# **MAC THOMPSON SITE PLAN**

## **STAFF REPORT #4**

February 9, 2022

**PLAN UNDER REVIEW:** MacThompson Site Plan, 48 Lowell Road, Hudson, New Hampshire 03051, Tax Map 190 Lot 191, Hudson, New Hampshire; prepared by Benchmark LLC, 1F Commons Drive, Suite 35, Londonderry, New Hampshire 03053; prepared for owner MacThompson Realty, Inc., 3 Marmon Drive, Nashua, New Hampshire 03060; consisting of 12 sheets with General Notes 1-36 on Sheet 3; dated August 3, 2021, last revised January 21, 2022.

**SIDEWALK DETAIL**  
NO SCALE

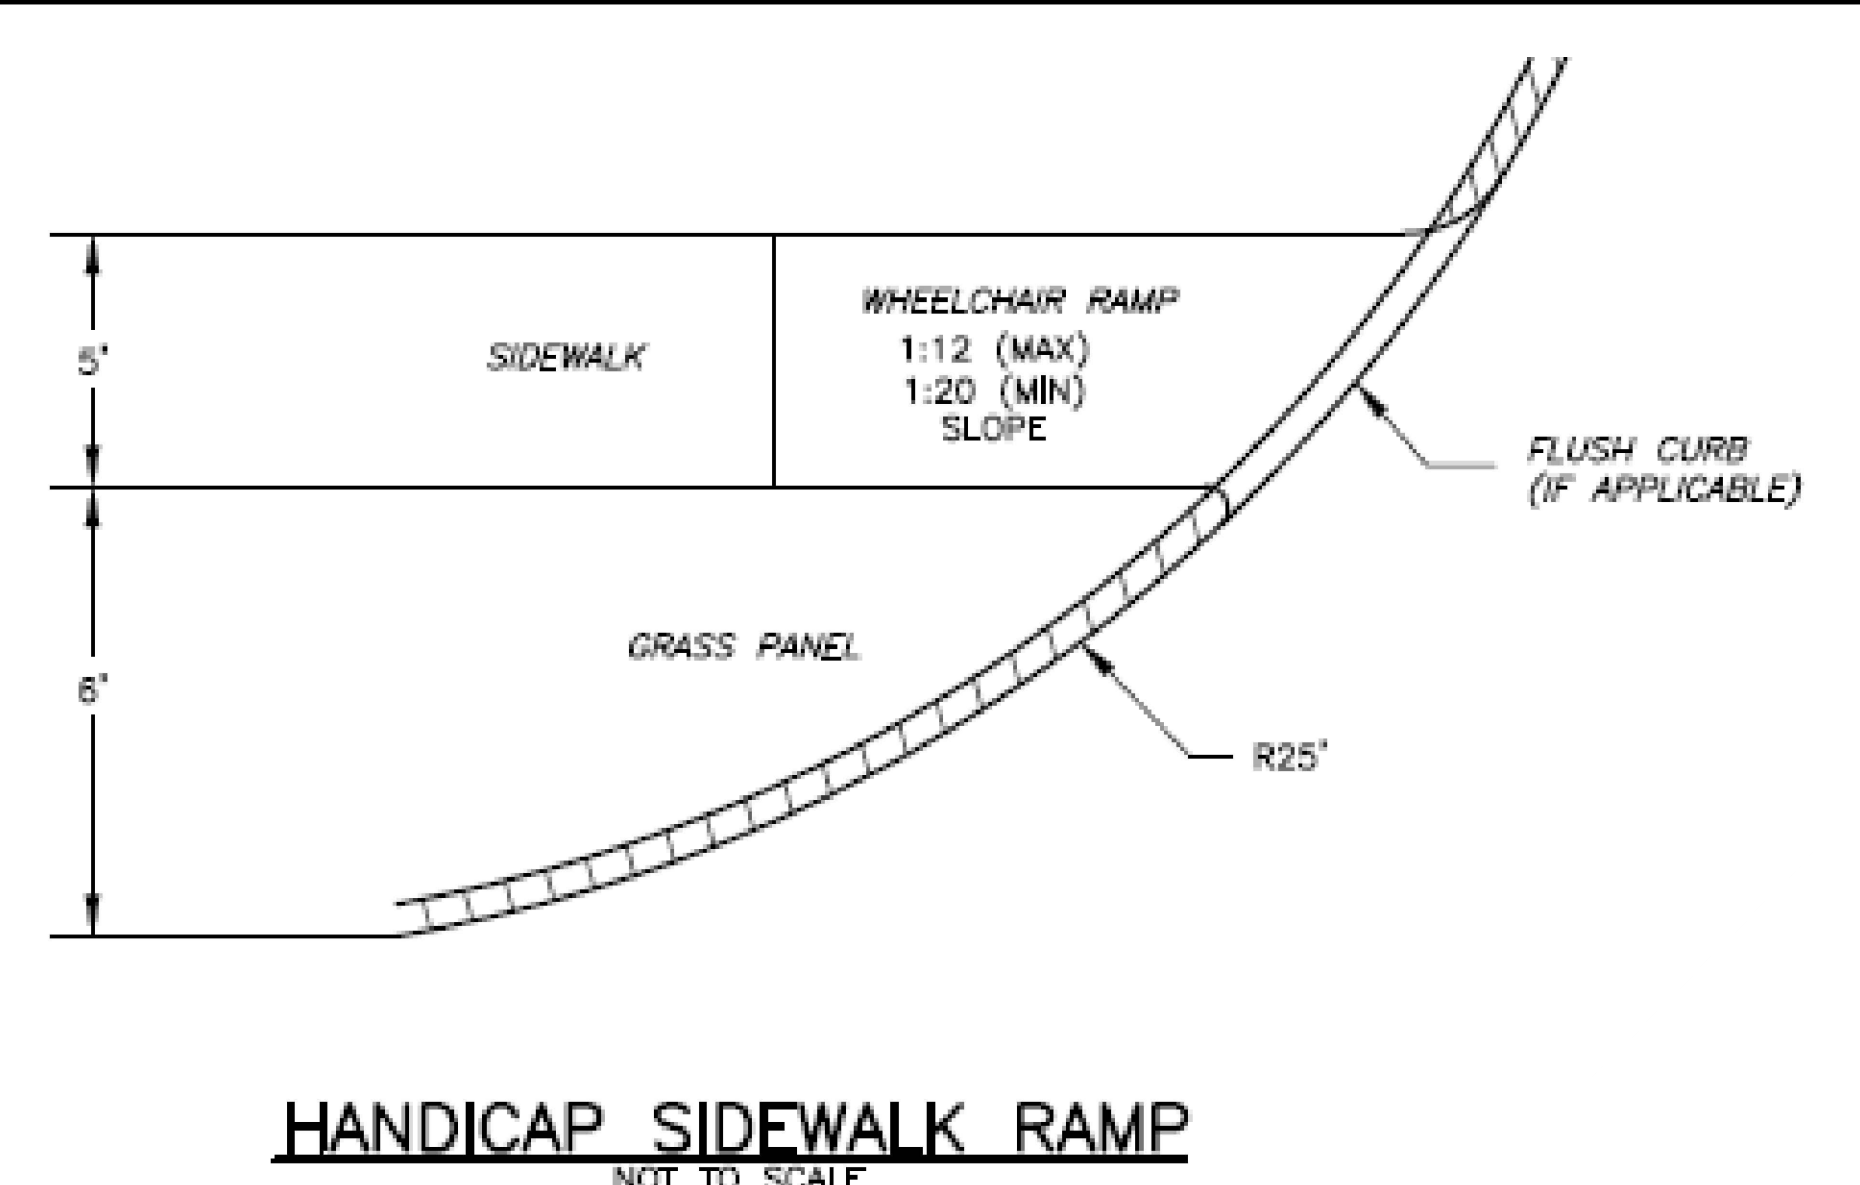
**Current Fuss & O'Neill Comment:** The applicant has noted it is to be poured concrete and added a detail to the plan set. The applicant should add a title to the detail.

**A title has been added to the detail on sheet 11**
